Docket No. 50-423
A04078

Reference: (1) B. J. Youngblood letter to W. G. Council, Request for
Additional Information for Millstone Nuclear Power Station,
Unit 3, dated May 25, 1984.

Millstone Nuclear Power Station, Unit No. 3
Response to Requests for Additional Information

FIGURE Q480.37-1
 UPPER REACTOR CAVITY
 NODAL ARRANGEMENT
 MILLSTONE NUCLEAR POWER STATION
 UNIT 3
 FINAL SAFETY ANALYSIS REPORT

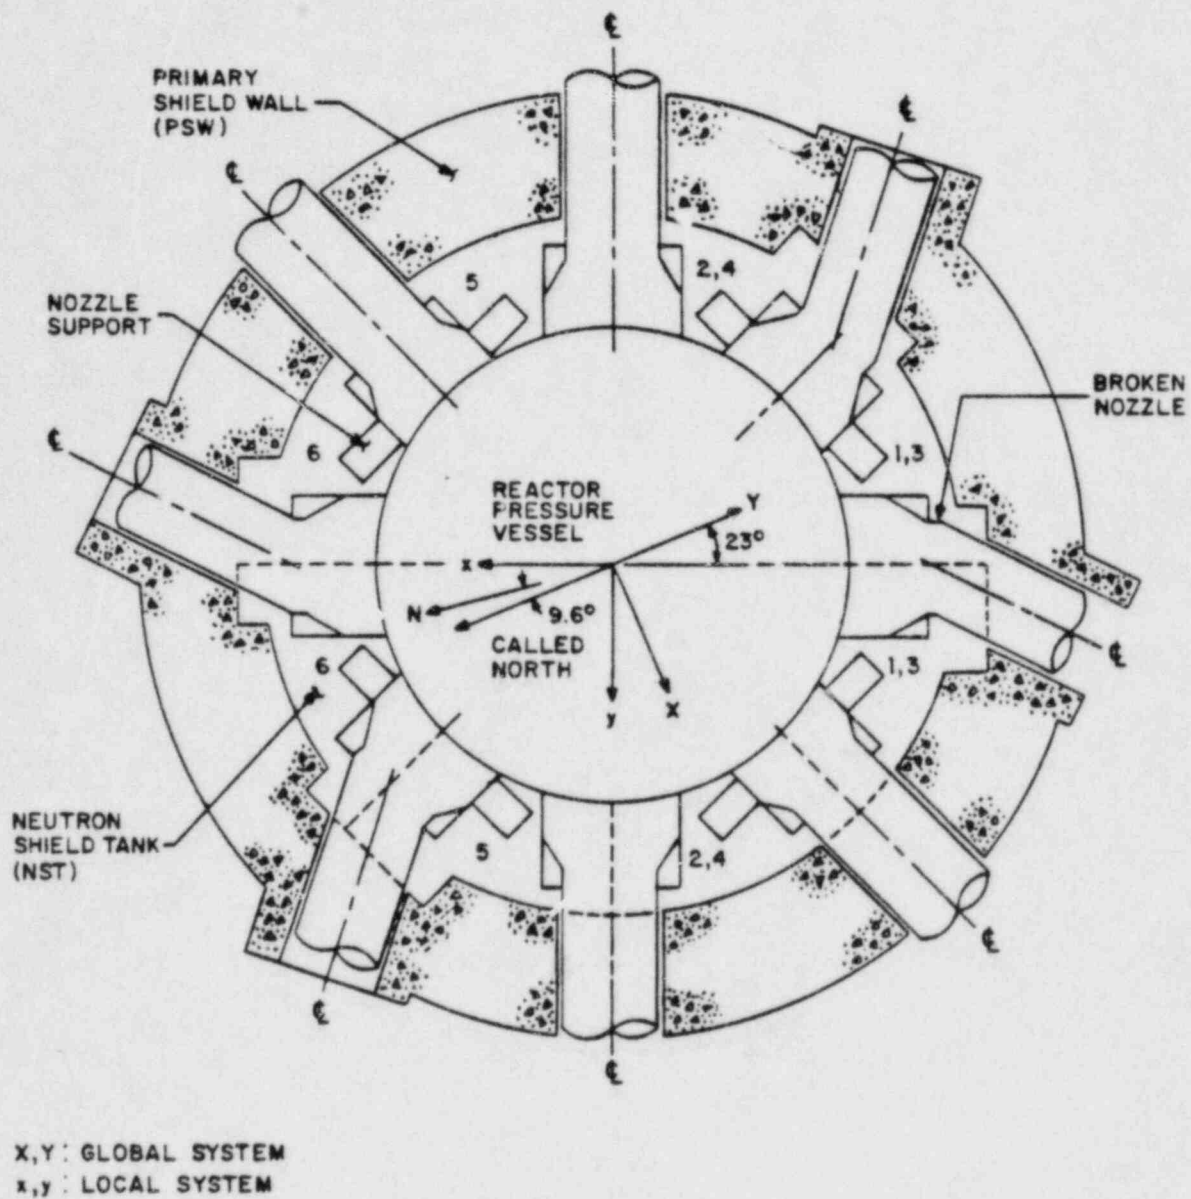
- a. Provide the peak and transient loadings on the major components used to establish the adequacy of the supports design. This should include the load forcing functions [e.g., $f(t)$, $f_x(t)$, $f_y(t)$] and transient moments [e.g., $M(t)$, $M_x(t)$, $M_y(t)$], as resolved about a specific, identified coordinate system. 1.12 1.13 1.14 1.15

- b. Provide the projected area used to calculate these loads and identify the location of the area projections on plan and section drawings in the selected coordinate system. This information should be presented in such a manner that confirmatory evaluations of the loads and moments can be made. 1.17 1.18 1.19 1.20 1.21 1.22 1.23 1.24 1.25

Figures Q480.37-1 and Q480.37-2 show the reactor cavity geometry for the postulated break at the inlet nozzle from Reactor Coolant Loop 2 (Cubicle B). The global coordinate system is defined as follows:

The nodal volumes for the asymmetric pressurization analysis, shown on Figures Q480.37-1 and Q480.37-2, also are assumed to be symmetric about the x-z plane. (See FSAR Figure 6.2-23 for overall nodal arrangement.)
